A Review of the Oconee-3 Probabilistic Risk Assessment

External Events, Core Damage Frequency

Brookhaven National Laboratory

Prepared for
U.S. Nuclear Regulatory
Commission

Figure 2.2 Event tree for sequences initiated by turbine-building flooding.
(OPRA Figure 9-77)

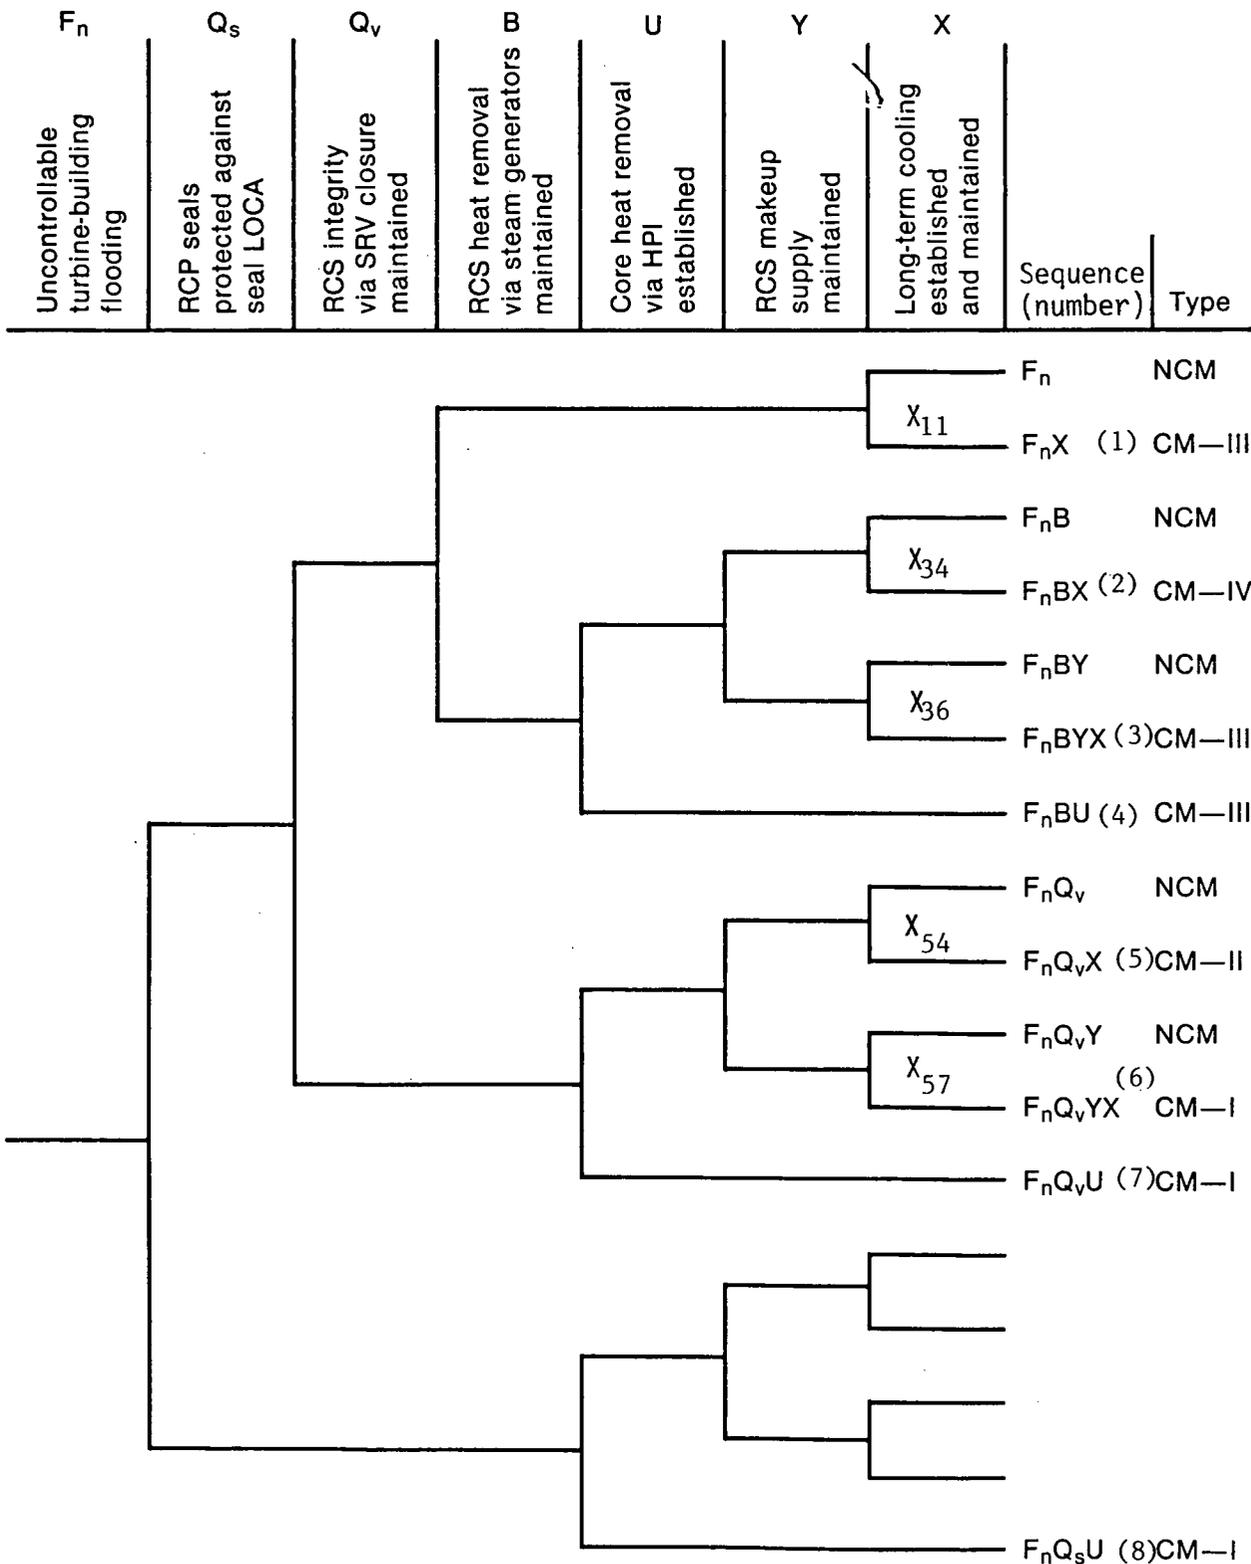
Eight event tree sequences initiated by a turbine building flooding are considered in the OPRA and are shown in Figure 2.2 (OPRA Figure 9-77); this review did agree with the event tree used in the OPRA.

The eight main sequences are shown in Figure 2.2. They start with one of the flood initiators. The first function considered is the seal injection. As the component cooling is assumed lost immediately following operator action to actuate the ESF, this function depends on whether HPI or SSF makeup is available. Thus sequence No. 8 is a seal LOCA sequence.

BNL did not change the main accident sequences. However, a split between the short-term (~2 hours) and late (~12 hours) components of X36 and X57 (long-term cooling) is more realistic; this split was used in the BNL review. As a consequence of this split, sequence No. 6 contributes to bins I and II, and sequence No. 3 contributes to bins III and IV; the contributions to bins I and III are dominant, as presented in Appendix B. Note that the eight sequences in Figure 2.2 were used in the BNL quantification for each sequence. After the minimal cut sets in each segment were obtained with the SETS code, the splits of the sequences 3 and 6 were performed.

Figure 2.3 Event tree for failure to maintain long-term SSF ASW suction after a flood.

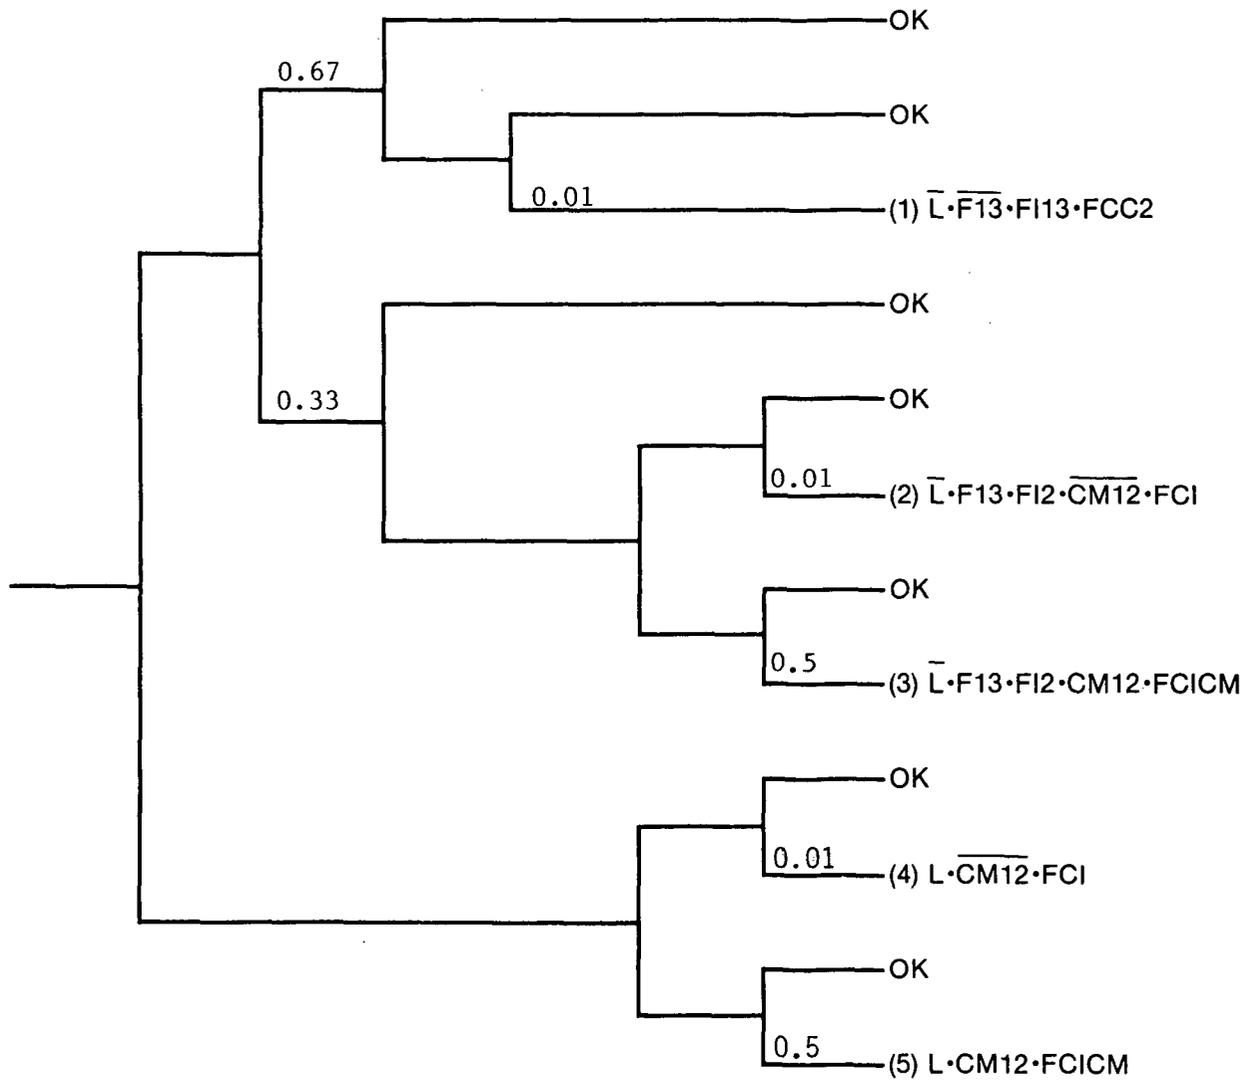
The sequences contributing to bins II and IV include a term for failure to maintain a long-term suction for the SSF ASW. The OPRA has analyzed this event separately, using the event tree shown in Figure 2.3. Table 9.41 of the OPRA provides the data used in their quantification. BNL reviewed this analysis and considers it to be a good representation of the main actions necessary to isolate the flood in the long term, and also to maintain long-term suction to the SSF ASW. A discussion of the top events in Figure 2.3 follows:

The "ASWLTF" is the result of the quantification of the event tree in Figure 9-93 of OPRA, shown in Figure 2.3 of this report. This figure, with the values given here in Table 2.7, can be used for its quantification. The ASWLTF is the conditional probability of losing ASW long-term suction given any flood initiator.

The above two operator actions are quantified in OPRA at 0.01. On the basis of this and BNL judgment, the third case of operator action of this type--establishing long-term suction to the ASW pumps--was also quantified by BNL at 0.01 (OPRA uses 5×10^{-3} for this in its quantification in Figure 9.93). This change is in part responsible for differences in the values of the BNL ASWLTF and the corresponding SFAPPS used in OPRA.

Figure 3.2 Oconee study seismotectonic model.

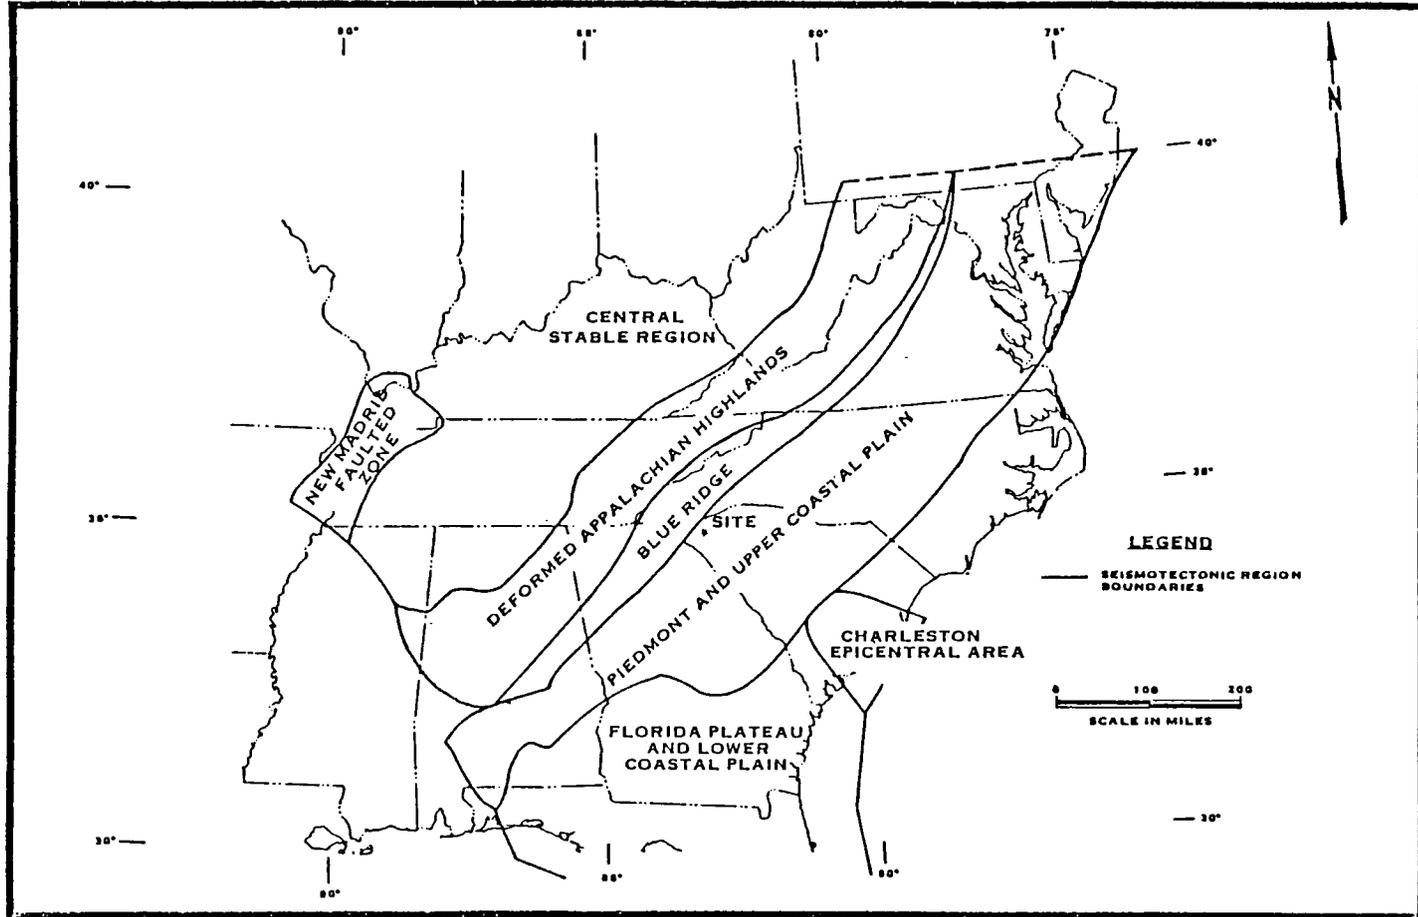
Figure 3.2 shows the seismotectonic model used in the OPRA to evaluate the ground motion hazard. This model was assigned a 1.0 weight, suggesting that there are no other realistic tectonic models that should be incorporated in the analysis or that all other relevant tectonic models are reasonably embodied in the model in Figure 3.2. The former view seems inappropriate, given that other studies available at the time²⁰⁻²² offer a number of alternative seismotectonic models. The latter view is a matter of practical concern since the only way to actually evaluate whether the results of other sources are implicitly included is to run the actual cases.

Figure 3.3 U.S. Geological Survey seismic sources near the Oconee site (Reproduced from Reference 21).

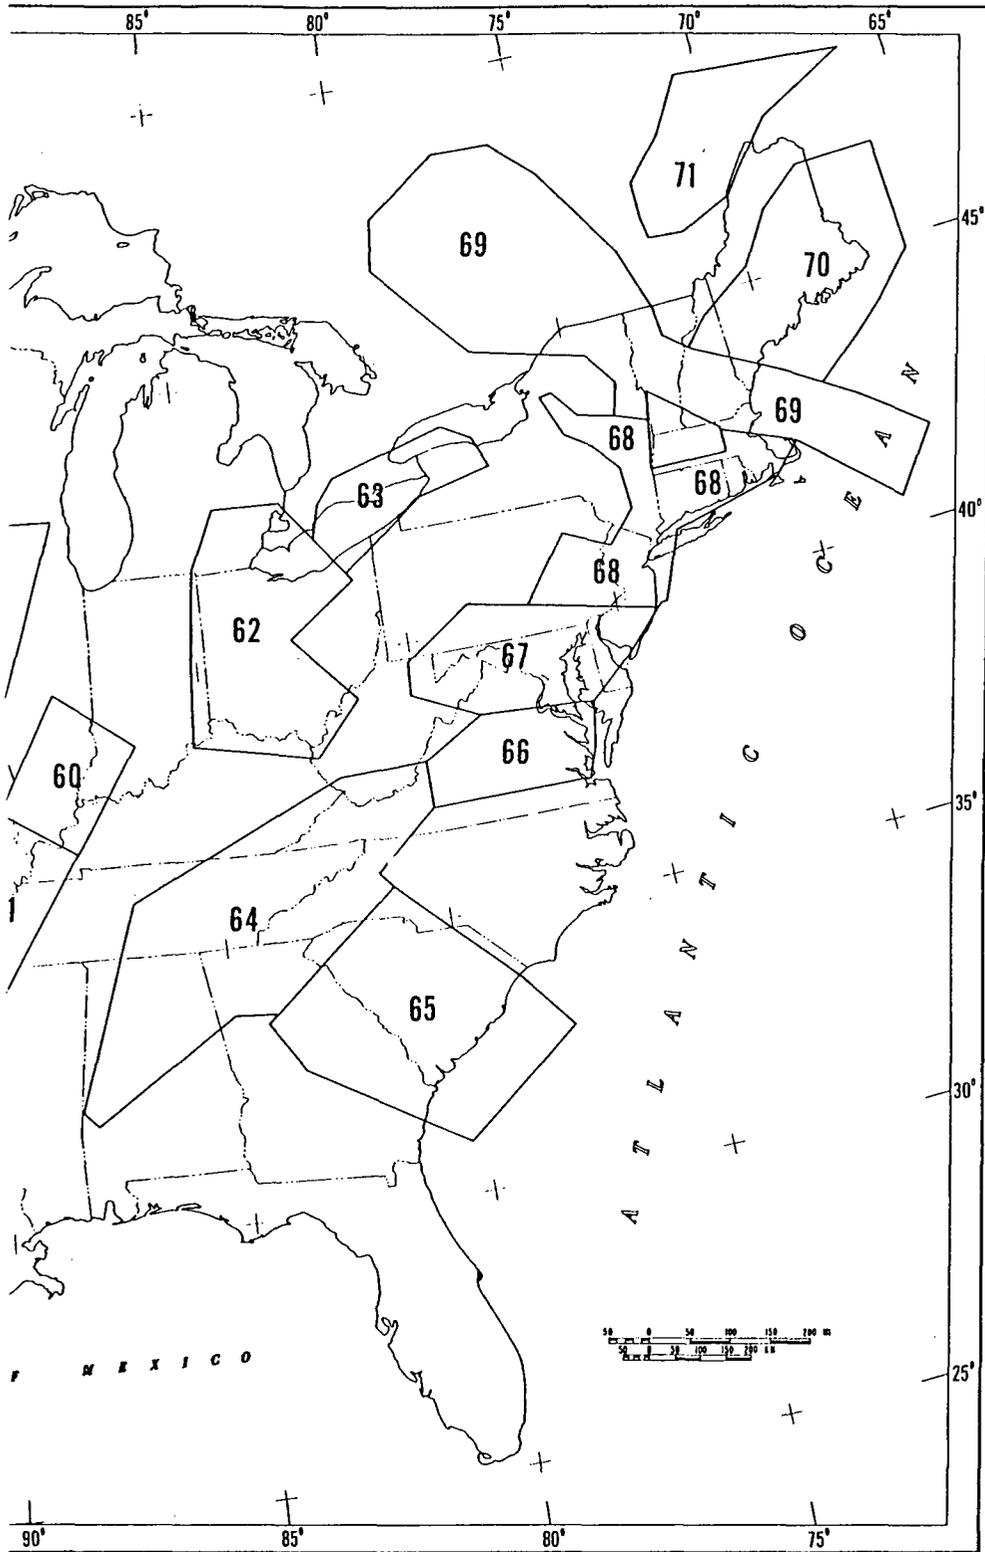
A comparison of the Oconee seismotectonic model with the 1976 USGS study²¹ and the initial Lawrence Livermore National Laboratory seismic hazard study²⁰ was made. Figure 3.3 shows the USGS source areas used in their 1976 study. Relative to the seismic hazard at the plant, USGS source areas 64 and 65 represent an alternative seismotectonic model to that used in the Oconee study. One consequence of this model is the fact that the Charleston zone (No. 65) is considerably closer to the plant site. As a result, this model would allow Modified Mercalli Intensity X events to occur much closer to the plant. It is anticipated this would result in a higher estimate of the hazard at the plant.

In Figure 3.3 the USGS source areas in the vicinity of the Oconee plant are shown as defined in their 1976 study. The USGS zonation is considerably different from that used in the Oconee study. In fact they parallel closely the source areas suggested by Bollinger²² (see Figure 3.6). In Table 3.4, the seismicity parameters for source areas 64 and 65 are reproduced from Reference 21. Recall that the 1976 study was completed before the Oconee analysis.

Figure 3.7 Comparison of the best estimate ground motion models from the LLNL ground motion panel for magnitudes 5 and 7 and the Ocone attenuation relationships.

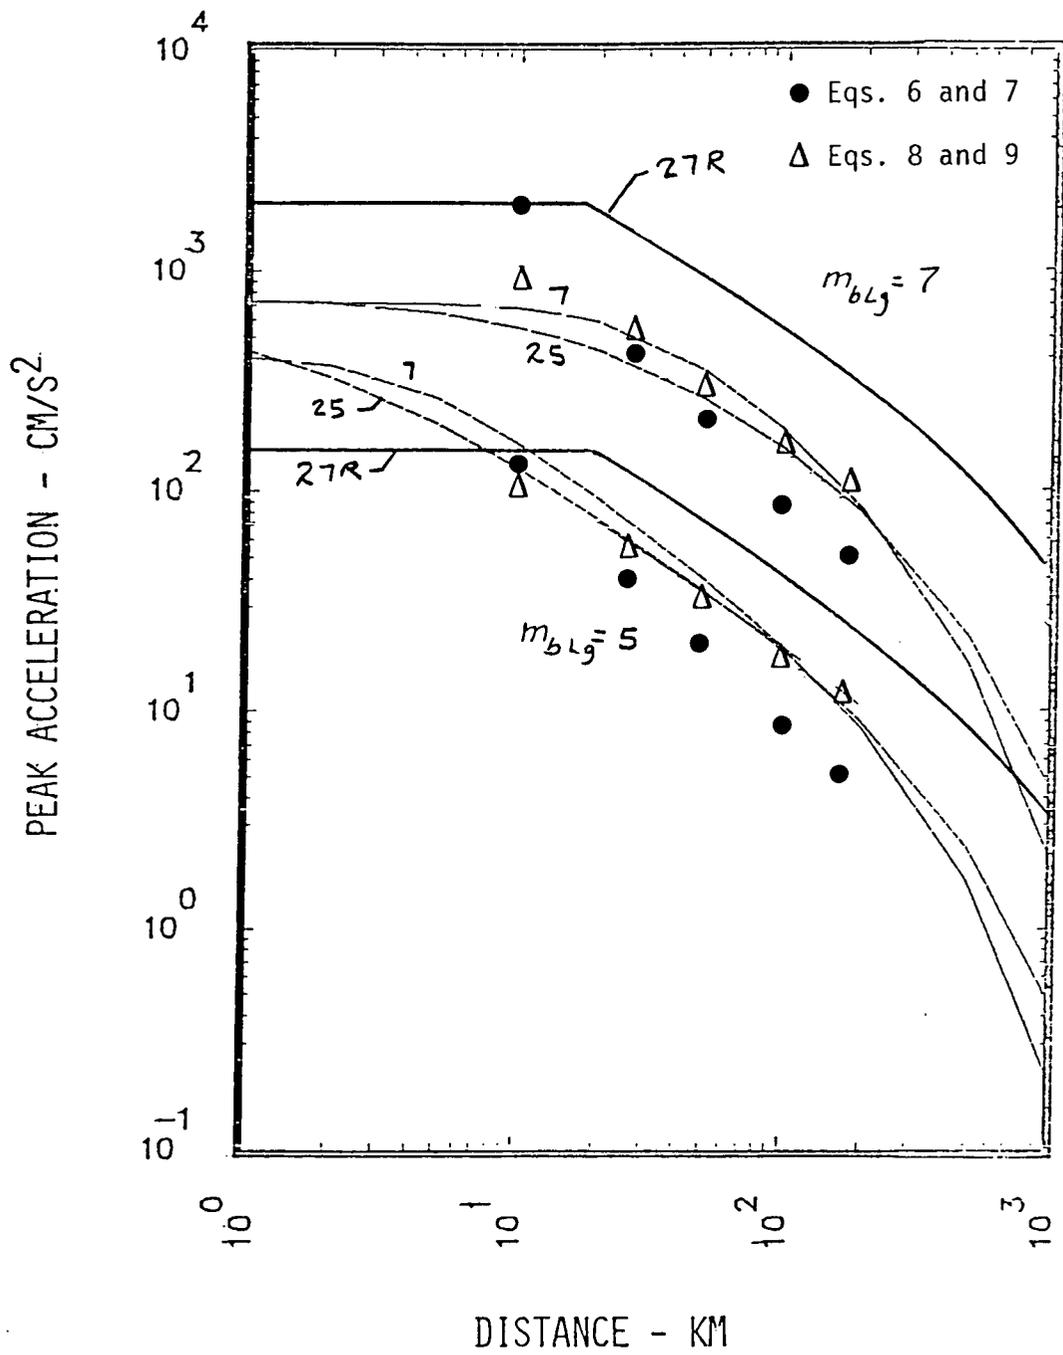
In Figure 3.7, the two attenuation models used in the Oconee study are compared to the best-estimate ground motion models (for rock) selected by the experts in the SHCP⁵. To plot the curves, the relationship, $MMI = 2 M_b - 3.5$ was used to convert MMI to magnitude. Figure 3.8 presents a similar comparison with other models provided by the ground motion experts.

Figure 3.8 Comparison of the Ocone attenuation models and other models provided by the SHCP ground motion experts.

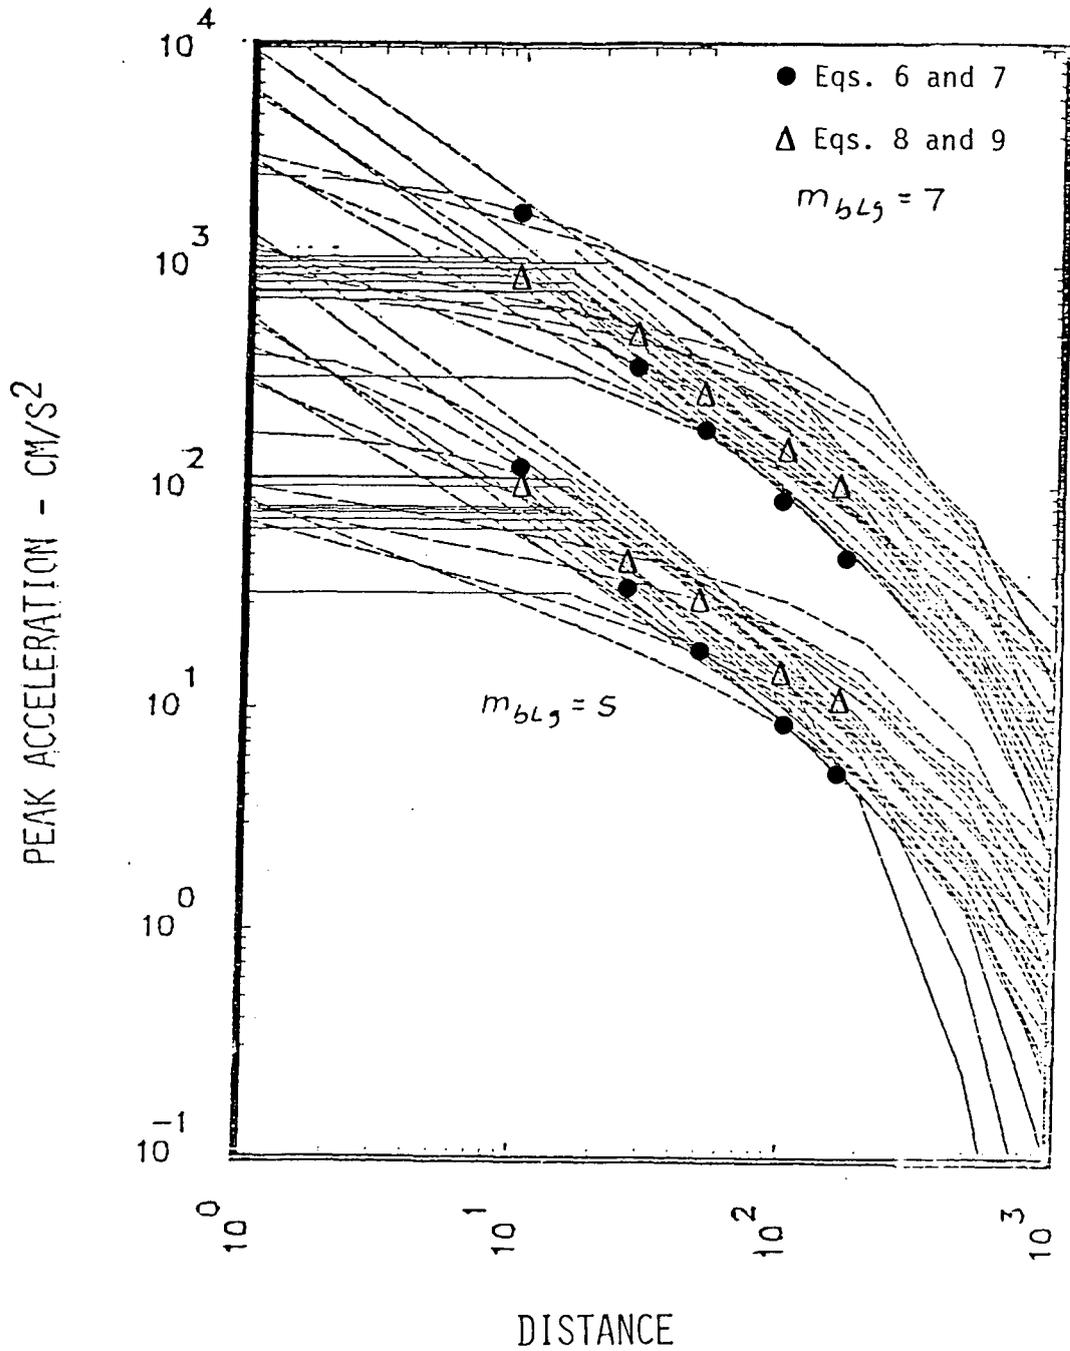
Figure 3.8 provides a different comparison. In this figure it can be seen that considerable variability can exist in the assessment of ground motion. In particular, the Oconee study incorporates only a part of this variability. A site-specific analysis, however, may not be expected to have as large a variability as a regional study, such as the SHCP. However, as shown in Figure 3.8 for magnitude 7.0, where the dispersion among the experts is great, the Oconee study accounts for only a fraction of the total variation.
